Rezoning Transportation Analysis

Petition Number: 2019-128

Date	Description
10-21-2019	First Review (EL)
06-26-2020	Second Review (EL)
08-21-2020	Third Review (KP)
09-21-2020	Fourth Review (KP)

TYPICAL SECTION

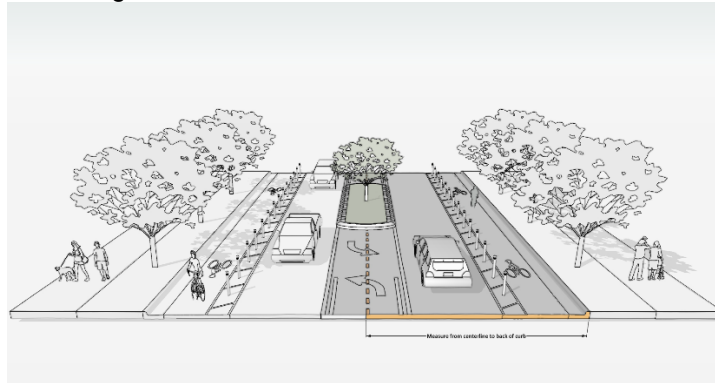
1. **Curbline** The proposed zoning district has a setback measured from back of the existing or proposed future curbline. **Updated Comment from 09-15-2020 Site Plan: Label and dimension the curb lines from the centerline.**
 - a. **Steele Creek Road:** The future location of curb and gutter will be constructed within the Steele Creek Road (NC 160) U-5766 project. The public meeting map and proposed cross section are provided below for reference.

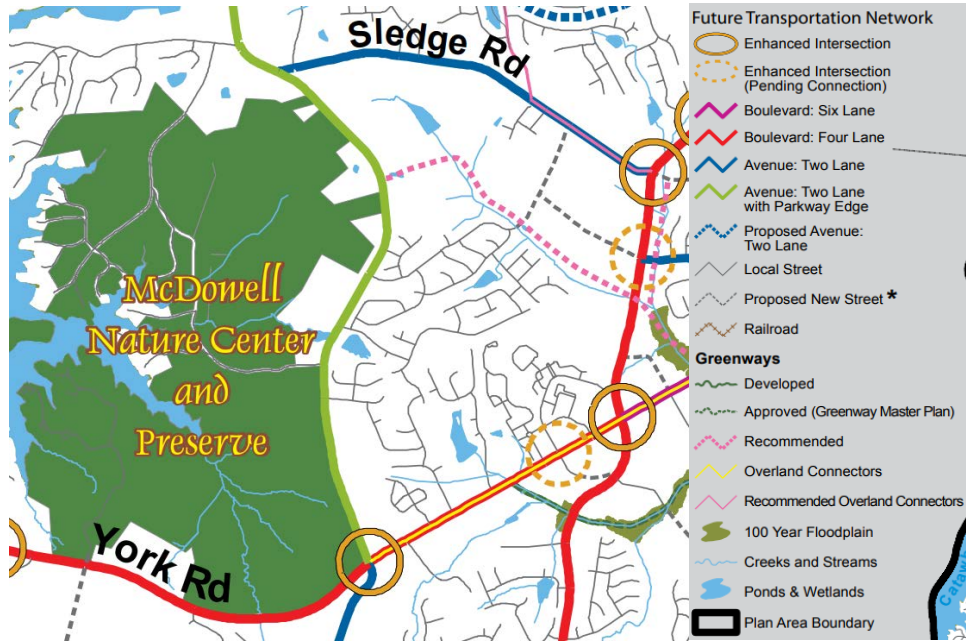
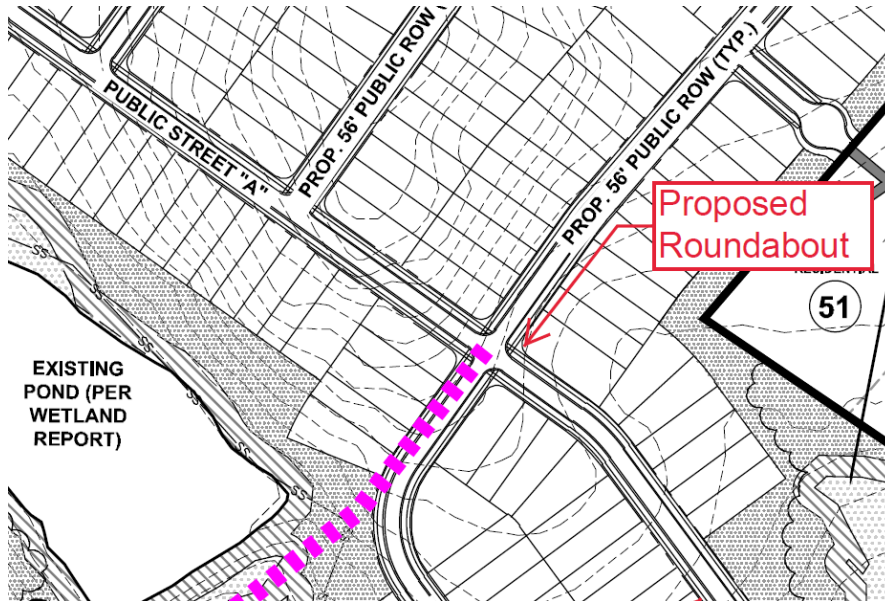
10. The petitioner should revise the site plan and conditional note(s) to specify each proposed street's USDG cross section.
11. The petitioner should revise the site plan and conditional note(s) to propose the recommended greenway alignment to the McDowell Nature Center and Preserve, per the Council-adopted Steele Creek Area Plan.

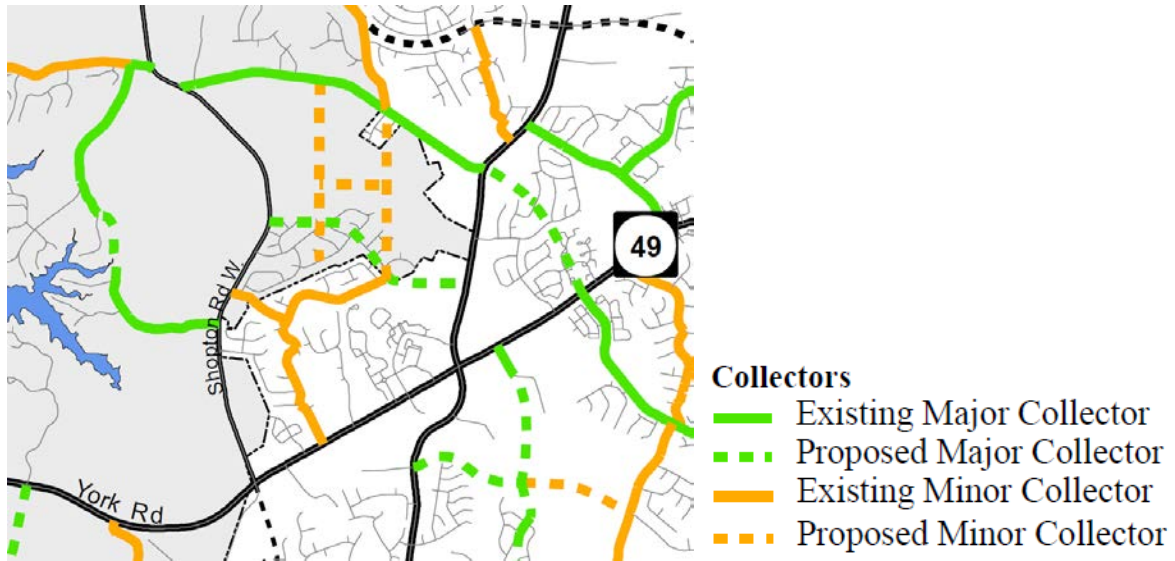
13. The petitioner should revise the site plan and conditional note(s) to revise Public Street "A" to a Local Collector Street Section, per CLDSM U-07, as required by Sec. 20-23(k) of the Subdivision Ordinance and the City-council adopted Collector Street Map. In lieu of the proposed 10-foot multi-use path, a 12-foot multi-use path should be provided along the western streetscape to provide an overland connector to the recommended greenway alignment to the McDowell Nature Center and Preserve.

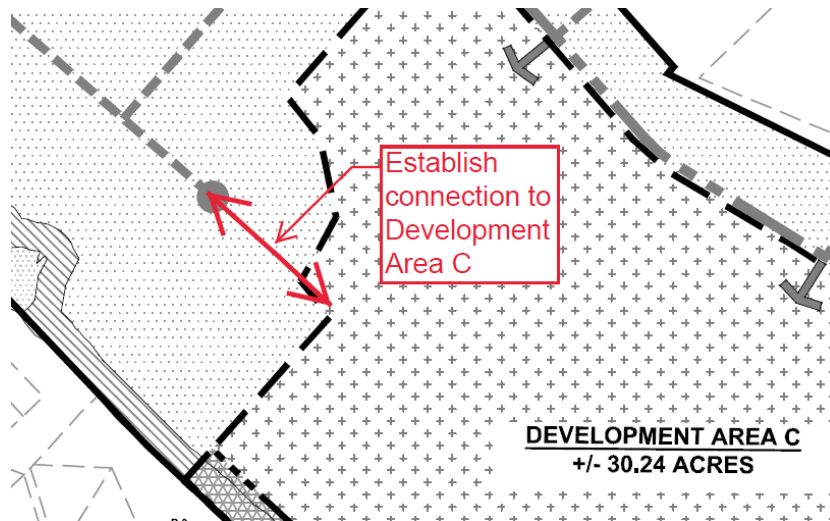
14. The petitioner should revise the site plan and conditional note(s) to establish a street connection to "Development Area C."

Updated Comment with 09-15-2020 Site Plan: "Development Area C" was removed and/or not labeled, however, access was provided. Please clarify.
